Technical Memorandum

Re: Response to Comments Regarding Potential Impacts of the Replenish Big Bear Project on the Lucerne Valley Land Discharge Location

Groundwater Wells at the Lucerne Valley Land Discharge Location

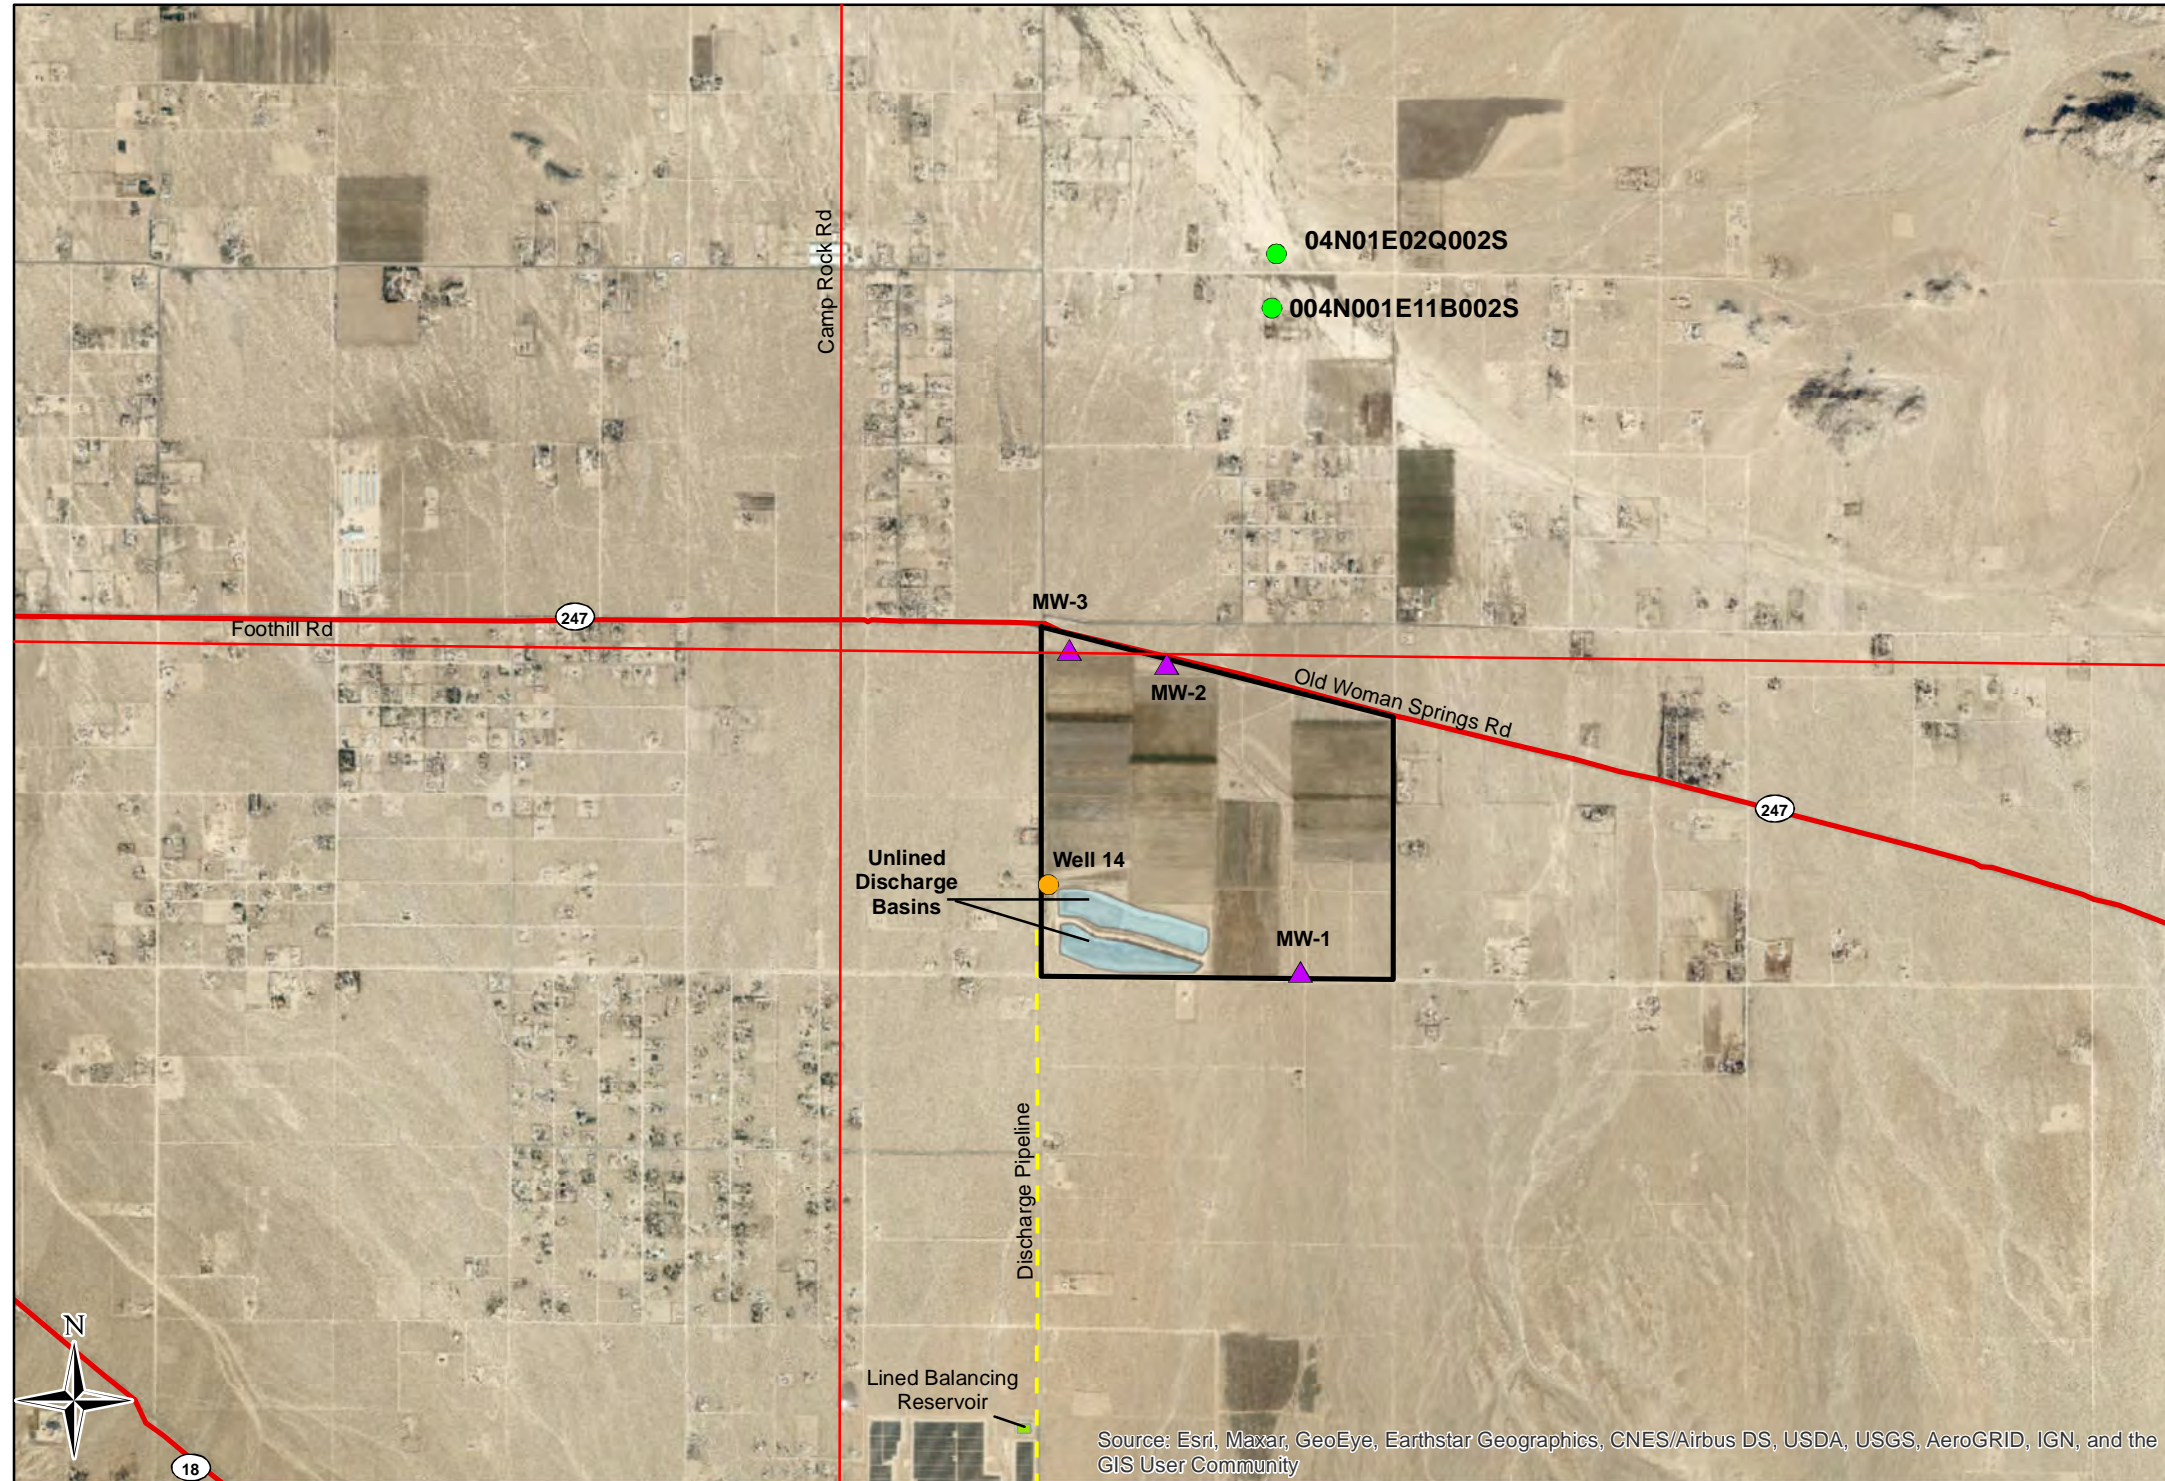
1. Have current and historical discharges to the LVDL contributed to surface or near-surface water flow in the natural wash located approximately 1-mile north of the site?
2. Have discharges to the LVDL caused higher Total Dissolved Solids (TDS) and nitrate concentrations in groundwater beneath the site than otherwise would have occurred absent the discharges?

It is assumed that the wash in question is the unnamed wash located approximately 0.8-mile northeast of the LVDL (see Figure 1). This wash is ephemeral, meaning that surface water flows in the channel only during periods of extreme above-normal precipitation. A review of historical aerial imagery (i.e. Google Earth) shows that this wash is dry in all historical images available since 1985 although its presence indicates that water has flowed in it periodically.

Based on a review of groundwater level data from wells located north of the LVDL and within or adjacent to the wash, it is not possible that groundwater recharge from surface discharges to the LVDL have caused surface and/or near-surface flow of water in the wash. Available

groundwater level records from 1994 through 2020 indicate that groundwater near the wash has never been shallower than approximately 110 feet below the land surface (see Figure 2). Records from two wells were obtained from the United States Geological Survey (USGS) National Water Information System (NWIS) online water database. Groundwater levels near the wash haven't varied more than approximately 10 feet and for the well with the longest period of record, was approximately the same elevation in 2020 as it was in 1994. As discharges to the LVDL were occurring throughout this time, and as there is no evidence groundwater levels have ever reached the ground surface at the wash, it is not possible that recharge from the LVDL has ever caused surface water flow in the wash.
